**Re: Defect Information Report – Supplemental Report No. 5
10V-360, FL-583, Business Class M2 Headlight Height**

Subject: Business Class M2 Headlight Height

September 2011
FL583A
NHTSA #10V-360
Transport Canada #10-258

Fig. 4, Masking Tape Secured Around the Headlight Opening

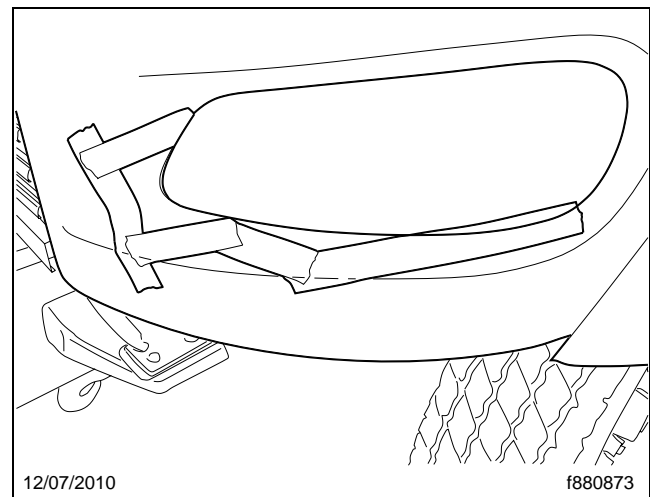
- 5.6 Close the hood.
6. Around the right and left headlights, apply masking tape around the headlight opening to provide a surface to trace a guide for the saw. See **Fig. 4**.

Fig. 5, Securing the Template to the Headlight Opening

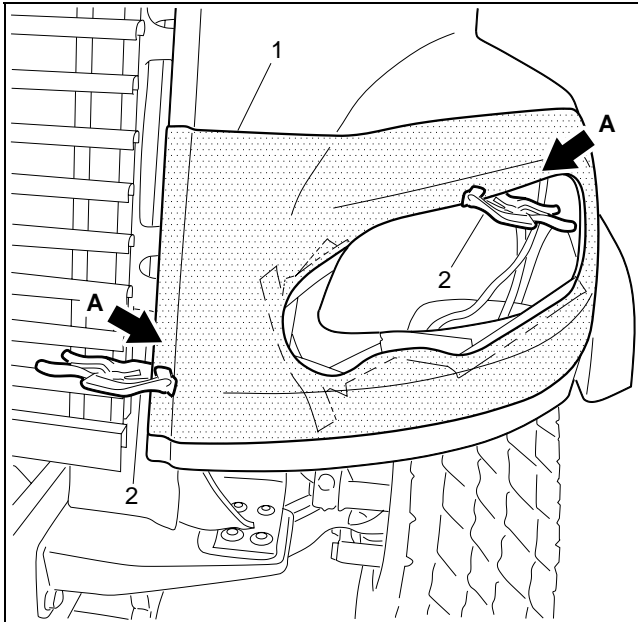
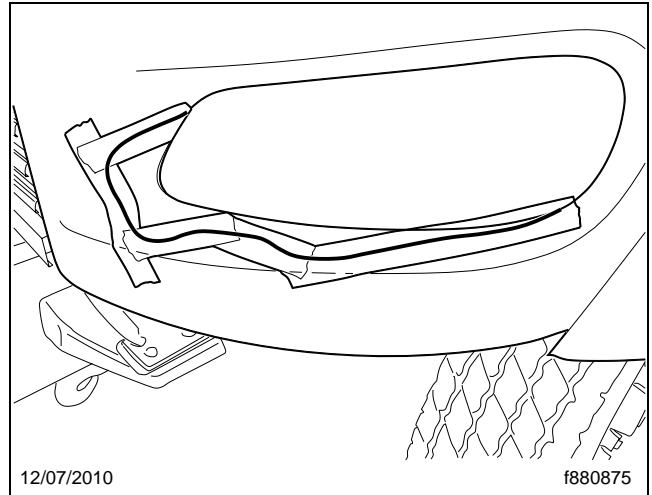
7. If not already done, label both hood templates for use with FL583 and FL592.
8. Position the appropriate template over each headlight assembly and secure it with two clamps. See **Fig. 5**. Secure one clamp on the top center of the opening, and the other clamp along the lower edge of the grille opening.

Fig. 6, Guide Line for the New Headlight Opening

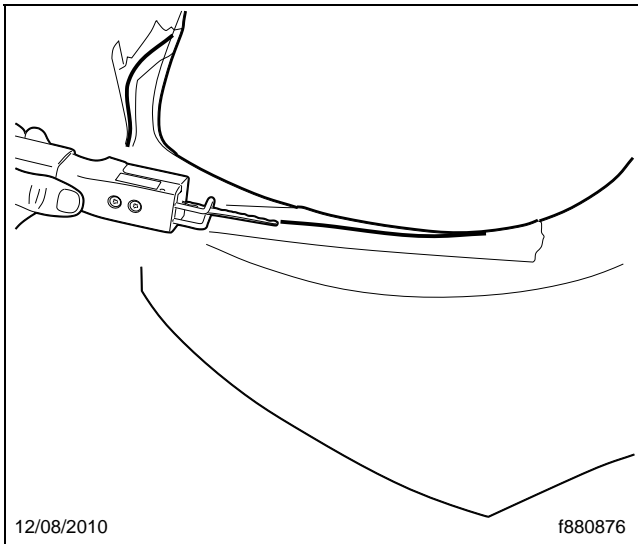
9. Draw an outline on the tape using the edge of the template on each side of the vehicle.
10. Remove the templates. The guide lines for the saw should be clearly visible. See **Fig. 6**.

Fig. 7, Cutting Along the Guide Line

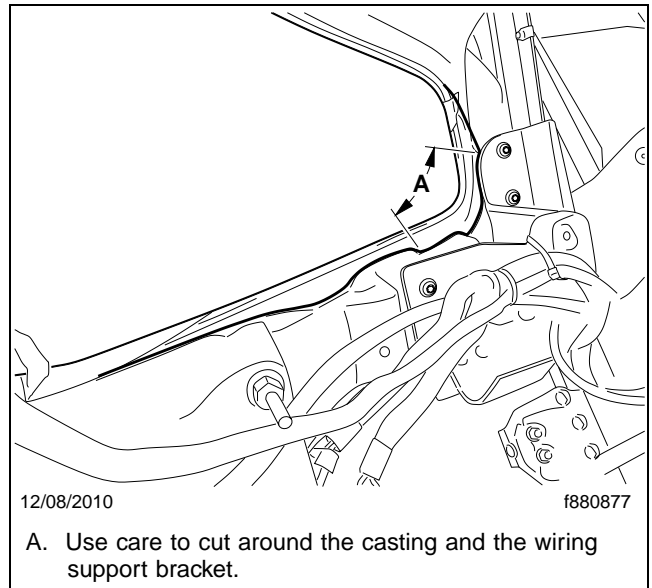
11. Using a metal saw, cut along the guide line. See **Fig. 7**. Use care to adjust the saw and cut around the casting and the wiring support bracket. Repeat on the other side of the vehicle. See **Fig. 8**.

Fig. 9, New Headlight Opening

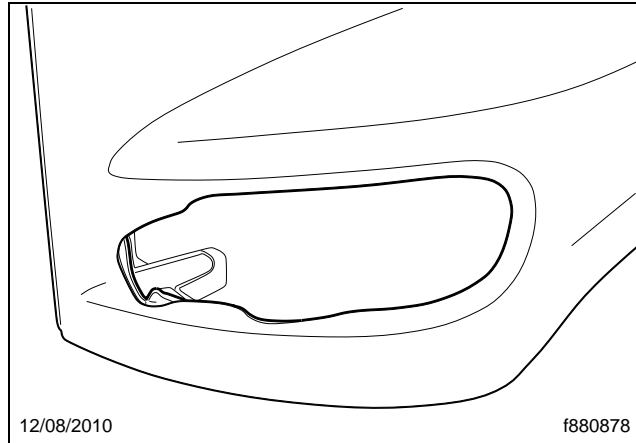
12. Remove the cut pieces of the headlight openings and remove any remaining tape. See **Fig. 9**.
13. Open the hood.
14. Install the new headlight assemblies. See **Fig. 10** and **Fig. 11**.
